**SERVICE BULLETIN - OPTIONAL**

Part No.: G13000, G13000(S), G13160

Description: <b>Digital Audio System Router</b>	
Service Manual: <b>P139-HD</b>	Service Bulletin No.: <b>P139-HD-603-0001</b>
ECO No.: <b>ECO1228</b>	Subject: <b>MMC to SD Card Upgrade</b>

Front Plate Label Location

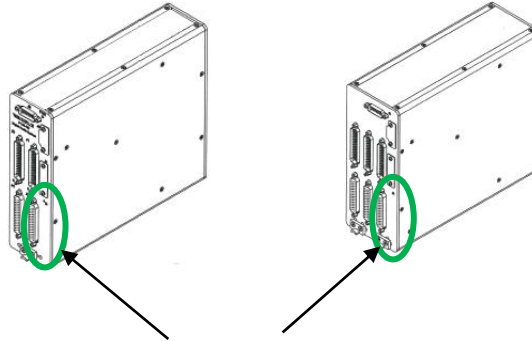
- 2.2.1 Once the firmware upgrade is completed, the unit shall be marked to indicate such.
- 2.2.2 Adjacent to the J3 connector on the G13000 and G13000(S) units and J6 on the G13160 unit, apply a label, indicating that the unit has been Memory Card upgraded.

This label can either be added by the customer (similar to below) or can be optionally supplied by AEM.

AEM label (PN 143-39-025):
